NORTH CENTRAL ELEMENTARY SCHOOL 1

AUSTIN INDEPENDENT SCHOOL DISTRICT
AUSTIN, TEXAS

01 FIRST FLOOR PLAN - AREA 1 - PLUMBING

01 FIRST FLOOR PLAN - AREA 5 - PLUMBING

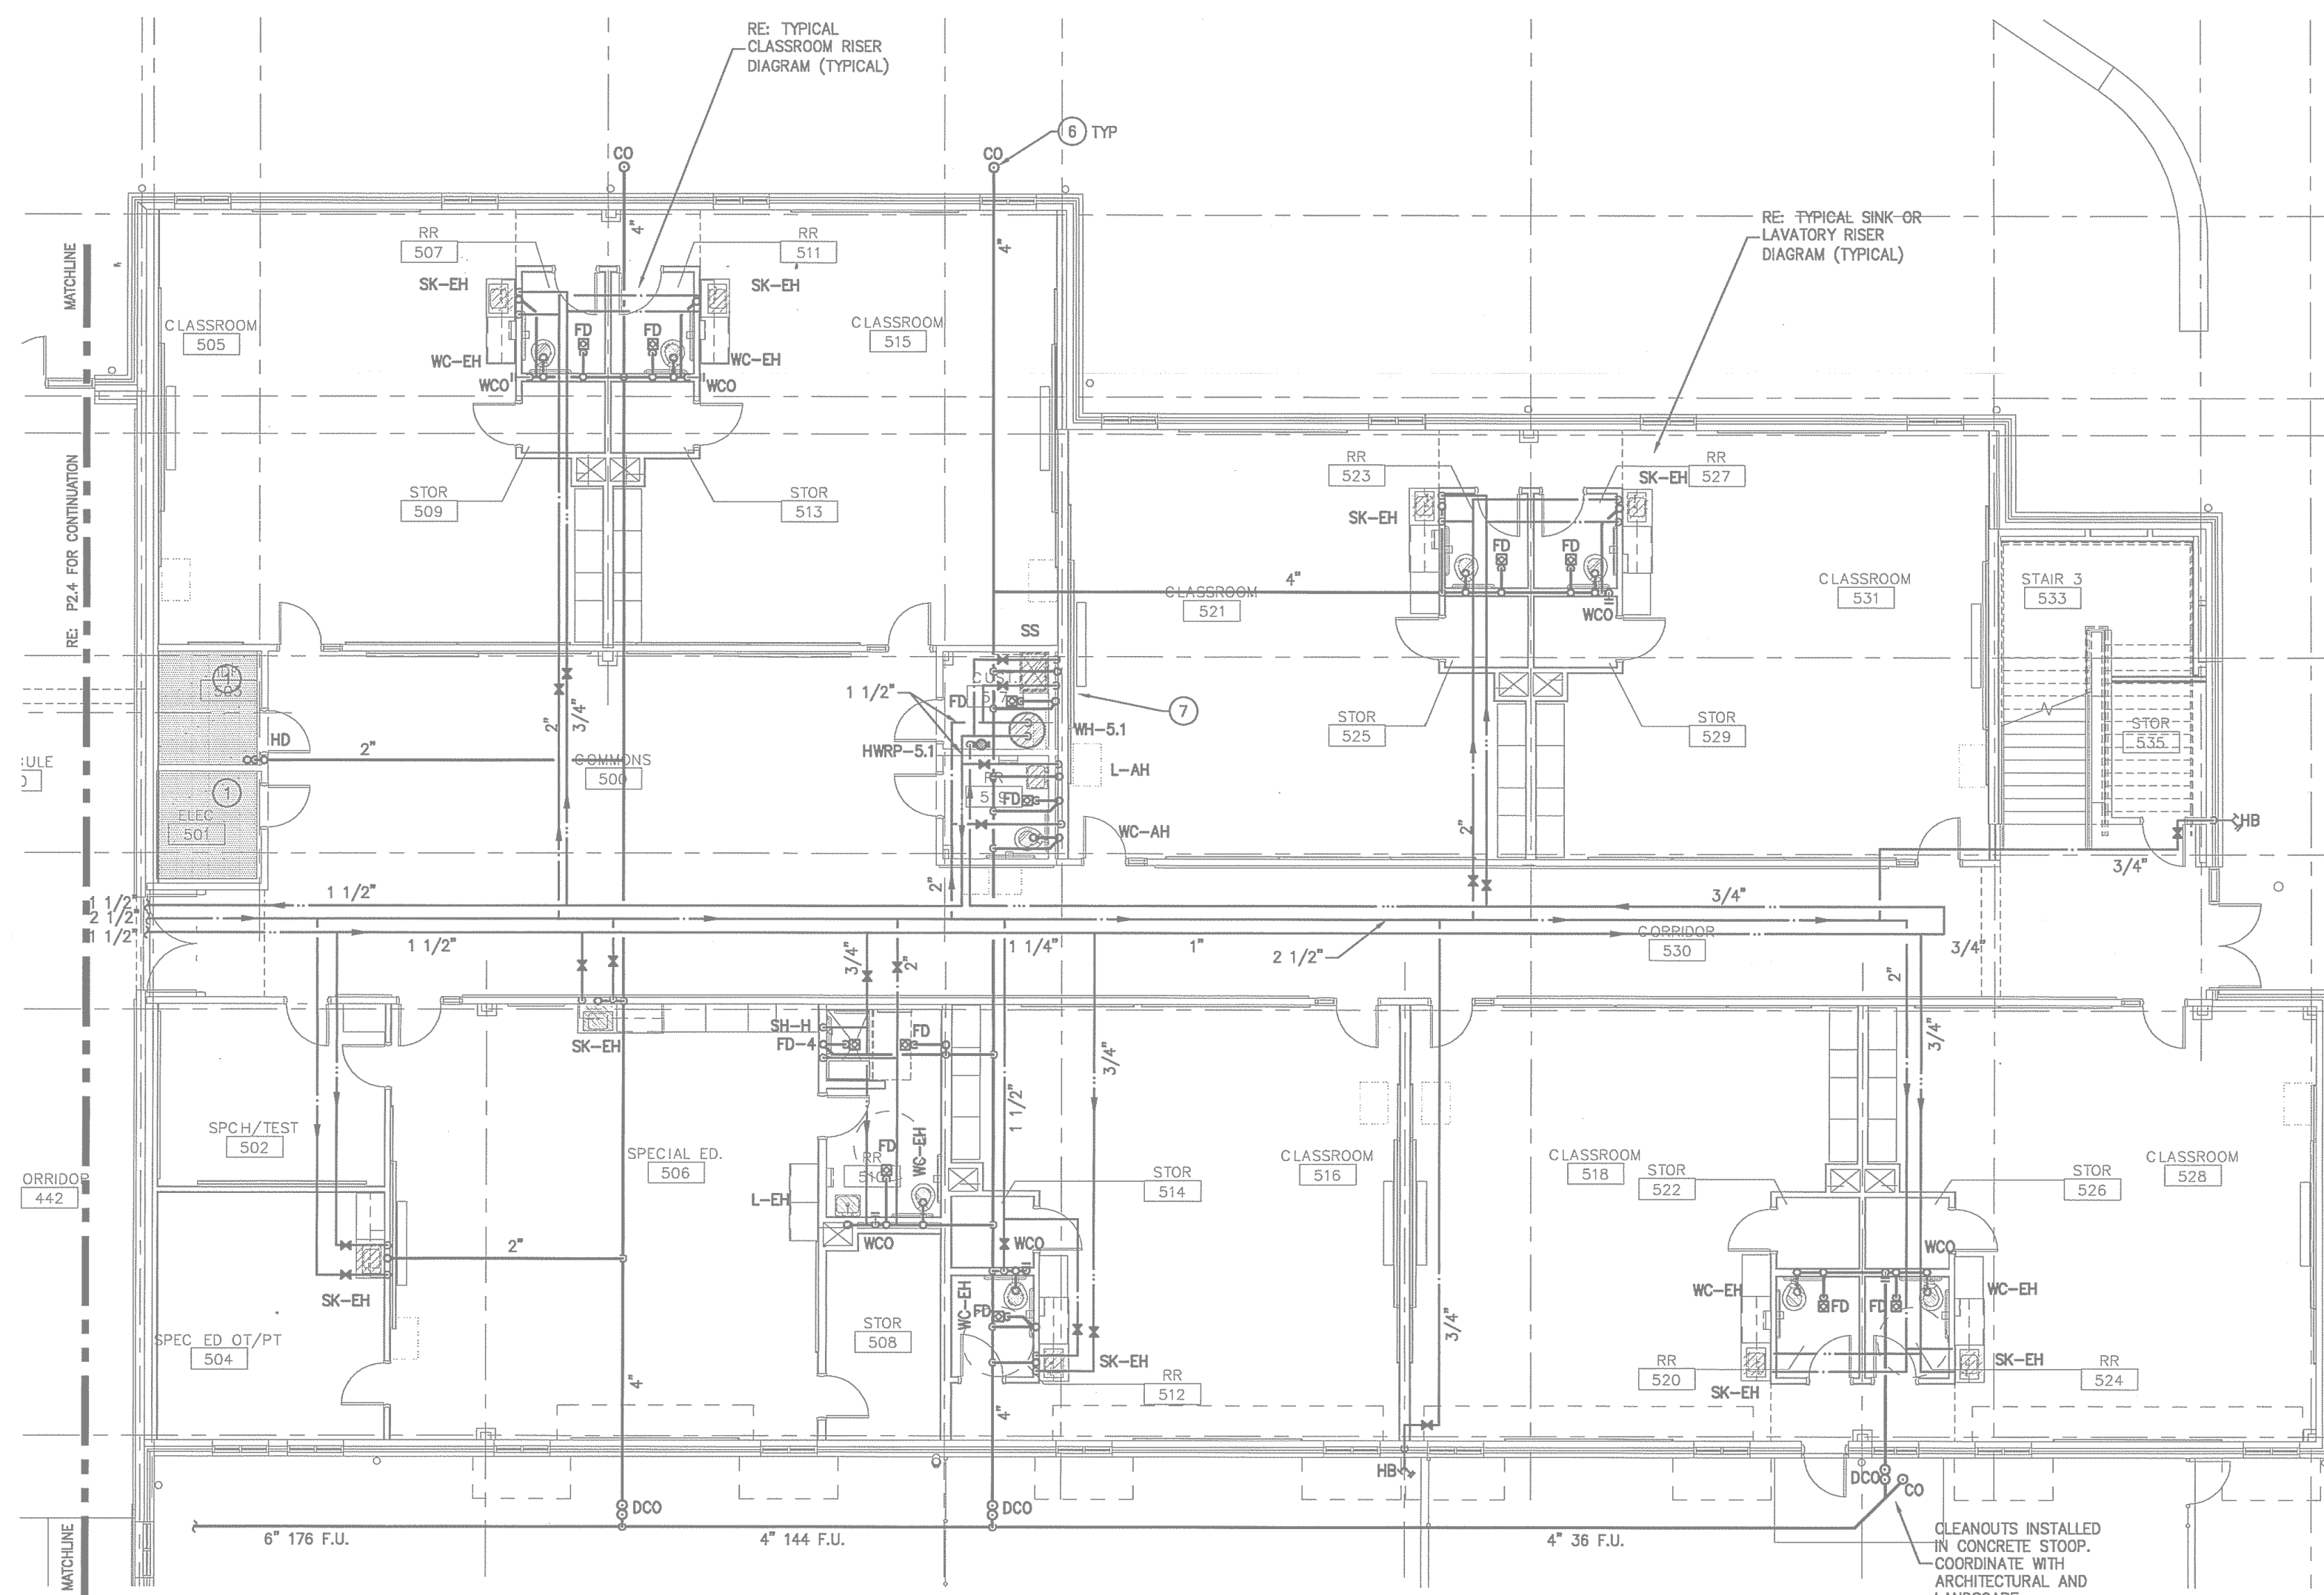
When structurally feasible, traps for floor drains and similar fixtures shall be primed by methods utilizing gravity flow wastewater from acceptable plumbing fixtures. Fixtures used for grease or food particle wasting shall not be used for trap seal priming.

Plumbing fixtures must comply with adopted City of Austin codes and ordinances and State of Texas requirements for plumbing fixture rates:
Water closets- 1.28 gpf
Urinals- 0.5 gpf
Public lavatory- 0.5 gpm
Metered faucets serving the transient public

Lavatories
Hot water delivered from public-use lavatories shall be limited to a maximum temperature of 120°F by a device that conforms to ASSE 1070 or CSA B125.3. The water heater thermostat shall not be considered a control for meeting this provision.
